Subject: The Dow Chemical Company- License No. R-108; Docket No. 50-264

Enclosed is the DTRR Revised responses to RAI questions 6, 11, 15-1, 17-1, 17-3, 34, 35, 36-2, 41,52, 54, 56, 57, 61-3, 62-2, 64-1, 65-1, 65-2 in support of the license renewal.

DTRR Revised response to questions 6, 11, 15-1, 17-1, 17-3, 34, 35, 36-2, 41, 52, 54, 56, 57,
61-3, 62-2, 64-1, 65-1, 65-2

Figure 4. Upper grid

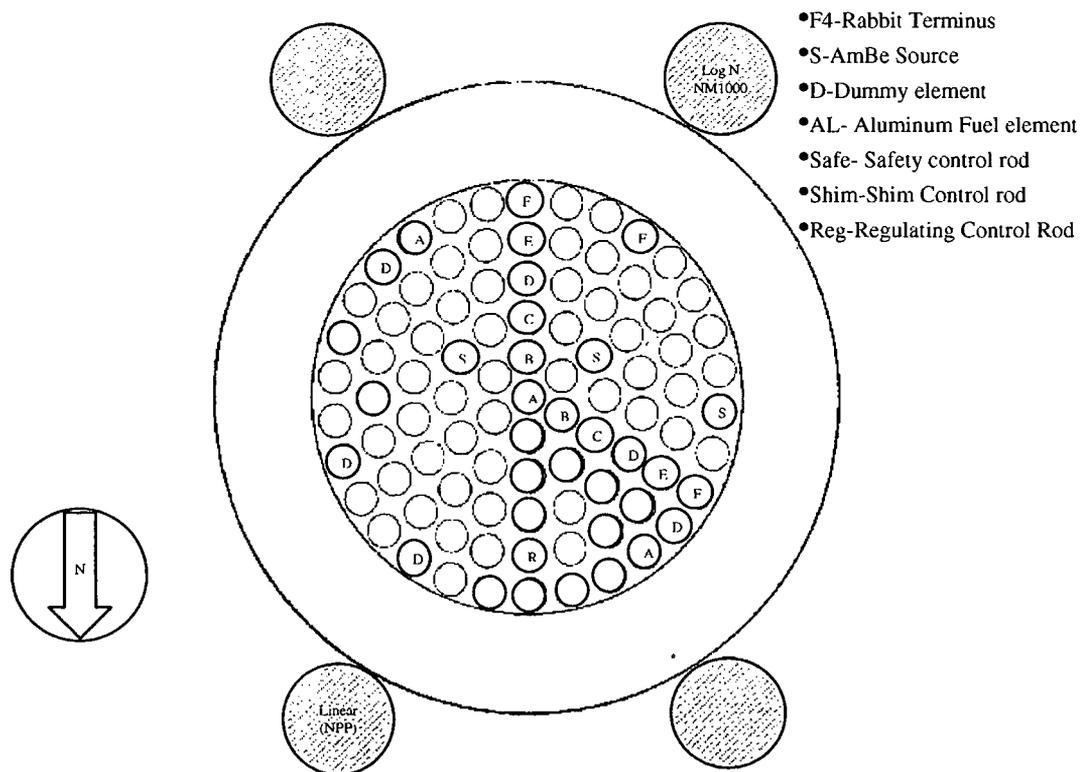
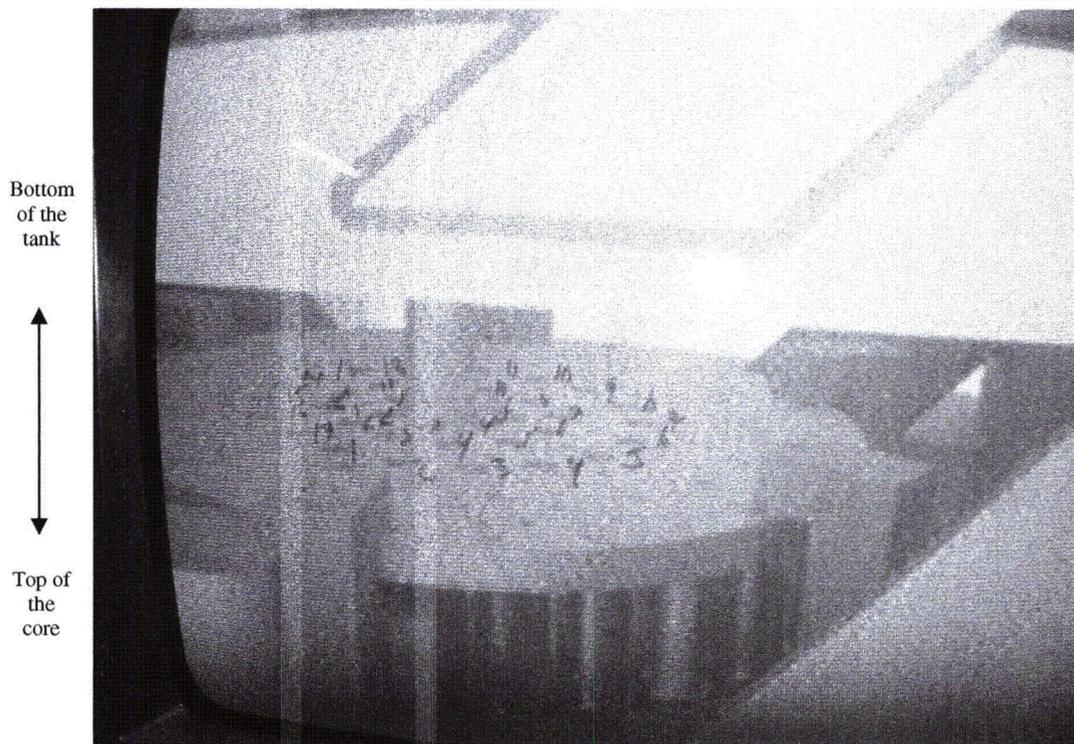
11. NUREG-1537, Part 1, Section 4.2.5, "Core Support Structure" requests the applicant to provide design information pertaining to the core support structure. DTRR SAR, Chapter D, does not provide sufficient information. Please provide figures depicting the upper and lower core plates and provide the dimensions and locations of all penetrations that allow coolant to flow through them.

Two aluminum grid plates fix the position of fuel elements, dummy elements and neutron source. Figure 4 is the schematic drawing of the upper grid plate with the position of the control rods, pneumatic transfer location and source indicated. The upper plate is 3/4 inch aluminum and 1.5 inch diameter holes to position the fuel, dummy elements, control rods, etc. The bottom plate is 3/4 inch aluminum and has holes to receive the end pins of the fuel and dummy elements. Thirty-six holes for the natural convection cooling are found on the lower grid plate. The water passes through the upper grid plate by means of the gap between the triflute section of the fuel and the upper grid plate. The penetrations on the lower grid plate are in concentric rings with 7, 12, and 17 holes, respectively. Figure 5 is a photograph of the lower grid plate. This photograph substantiates the as built drawings given by General Atomics, and previous Safety Analysis

In addition to these holes, the fuels are raised above the bottom grid plate by the fuel pin (5/8" diameter by 2" long). The gap between the fuel and the lower grid plate therefore allows the bottom coolant to flow, in an "open" configuration through the core from the bottom.

Figure 1. Upper grid plate

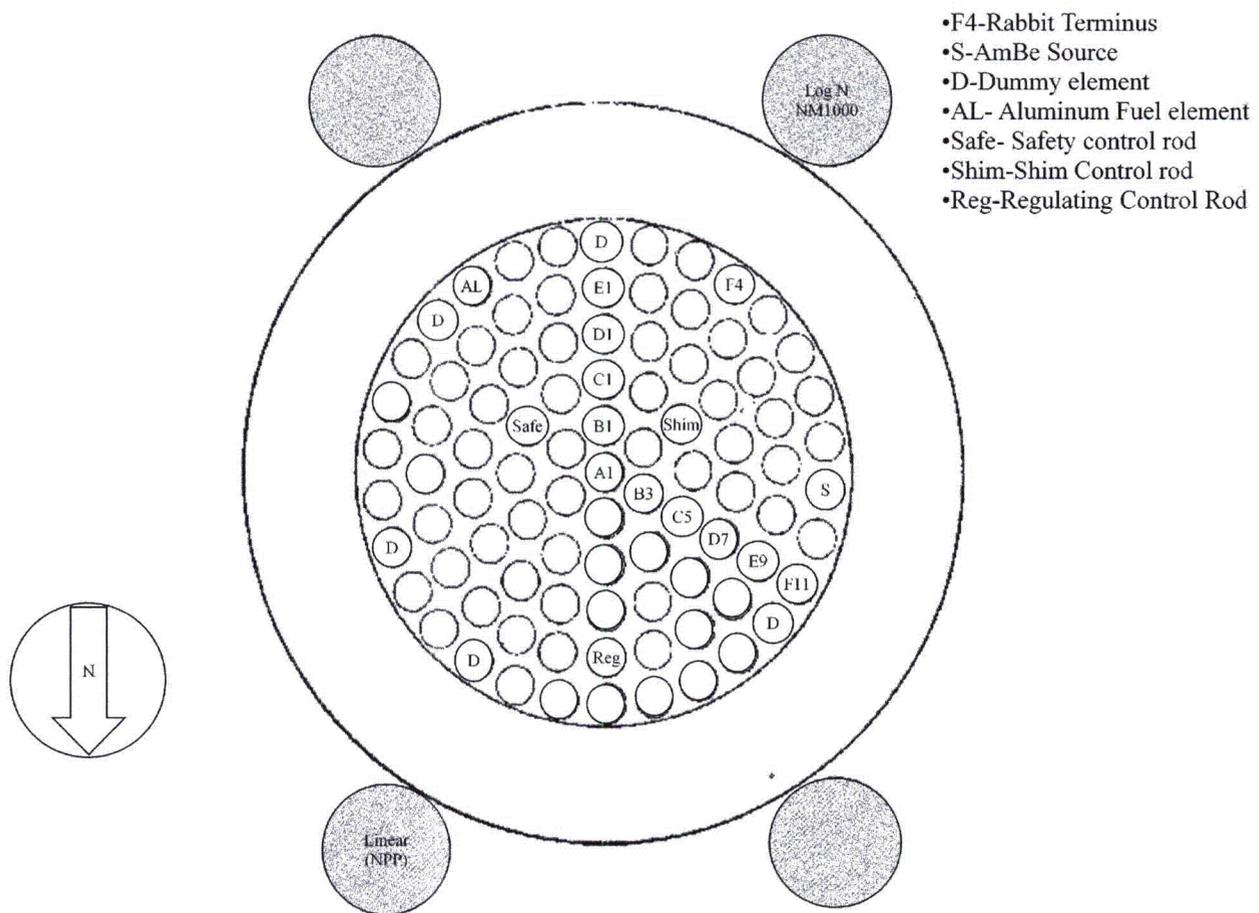
15.2 DTRR SAR, Section A.3, describes the original fuel configuration as having 75 stainless steel (SS)-clad elements and one Aluminum (Al)-clad element. The DTRR SAR does not provide information relating to the DTRR fuel element and control rod layout for the requested power level. Please provide a complete description of the LCC for the requested power level and provide a core diagram showing all components.

15.2 The core configuration is found in Figure 1. The core is loaded with 79 Stainless Steel clad fuel elements, 1 Aluminum clad fuel element and 5 graphite dummies.

Figure 34: Reactor room HVAC system showing Inlet and outlet units

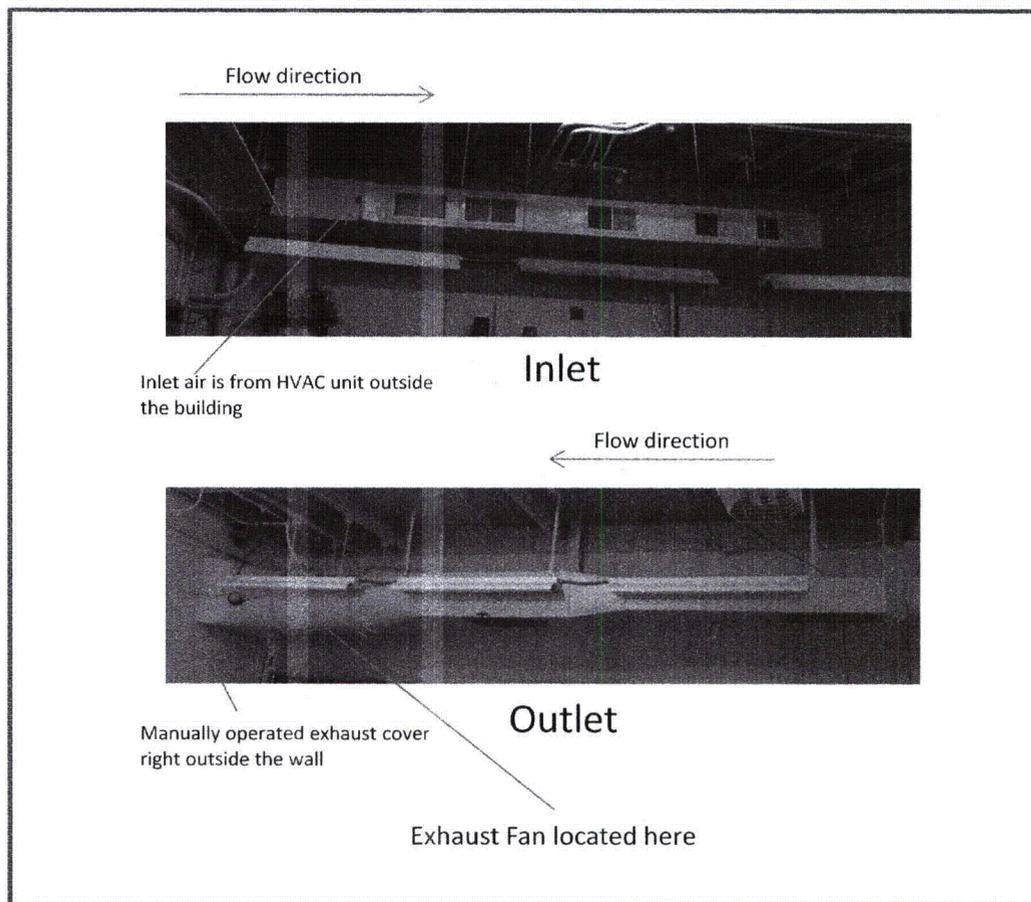
34. NUREG-1537, Part 1, Section 9.1, "Heating, Ventilation and Air Conditioning System" requests the applicant to provide a description of the heating, ventilation and air conditioning system (HVAC) and any manual or automatic functions. There is a brief description in DTRR SAR I.1 regarding this function with no schematics or illustrations. Please provide a more detailed description of the HVAC system and system functions and provide schematics of the HVAC system.

The HVAC for the reactor room of the DTRR is shown in Figure 34. The inlet to the reactor room is located to the north side of the reactor room. The outlet is located on the east wall of the reactor room. Both the inlet and the outlet fans can be shut off using a switch in the control room. There are two modes of operation of the HVAC system, 1) Normal operating mode and 2) Isolation mode. In the normal operating mode, both fans are operating and air is being sucked out of the reactor room and "conditioned-air" is being pumped in at the specified turnover rate. There are indicators, available to the operator, of the system status. These indicators are checked daily or whenever the reactor is operated. In the isolation mode, both fans are turned off and the doors are closed. There is a manually operated shutter outside the building which covers the exhaust. This shutter, which is normally opened, will be closed during isolation mode. There are no filters in the exhaust.

Figure 54. Diagram of Reactor Room and Adjacent Areas

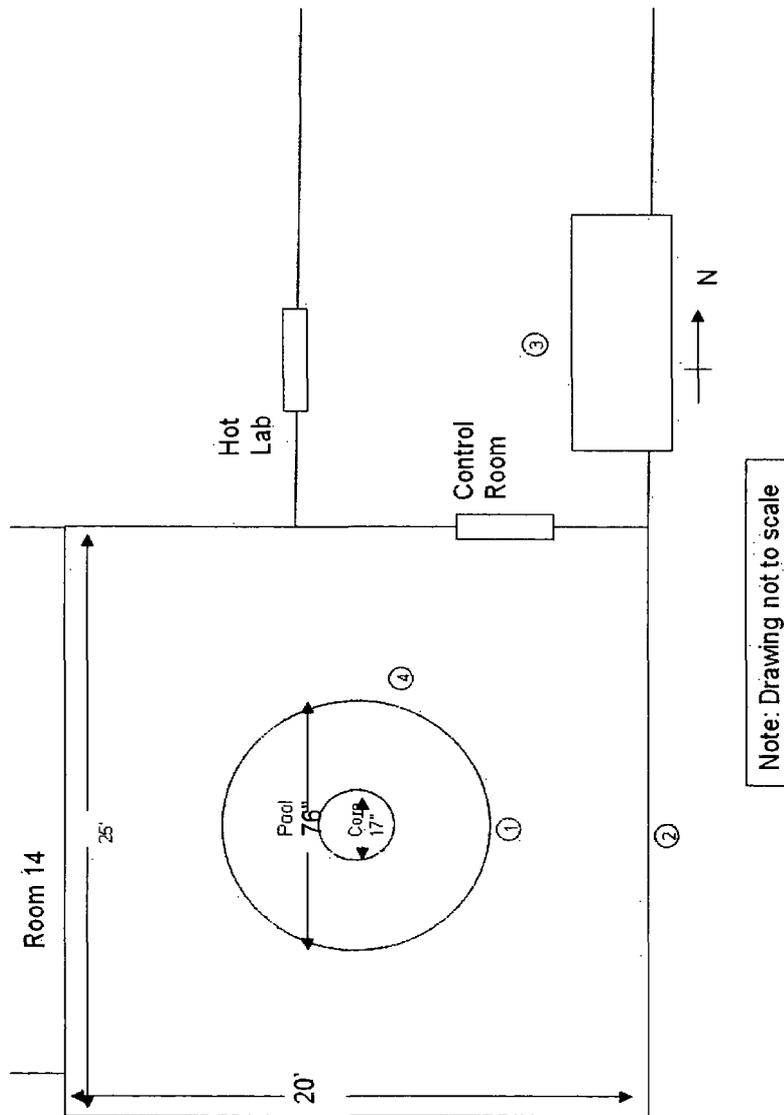
54. NUREG-1537, Part 1, Section 13.1.3, "Loss of Coolant" requests the applicant to provide analysis that assures that doses to the public that could result from a loss of coolant accident do not exceed 10 CFR Part 20 limits. DTRR SAR, Section M.1.1, Table 7 presents exposures resulting from a loss of coolant accident. There is no statement regarding occupational or public dose limits and whether they are met. Please explain this accident analysis in further detail and in terms of meeting the regulatory limits.

The water level in the surrounding area is above the core height and therefore tank breach will not result in a total loss of coolant. However, the analysis was completed for an uncovered core after an extended period of operation at 300 kW. The results are in the following table.

The elevated radiation fields generated from this accident will be highly collimated above the reactor pool. The core sits inside a 17" diameter opening in the reflector. The top of the reflector is 16' below the top of the 76" diameter reactor pool. Based on the largest potential angle that direct radiation may be emitted from the reactor, the direct radiation beam from the core will only have a diameter of 12.3 feet at the roof of the reactor room, which is still much smaller than the entire room. Therefore, workers and members of the public located outside of the reactor room will not be exposed to the direct radiation from the reactor core. Responders to the incident will also avoid the area of the room directly above the core in order to avoid exposure to the direct radiation from the reactor core.
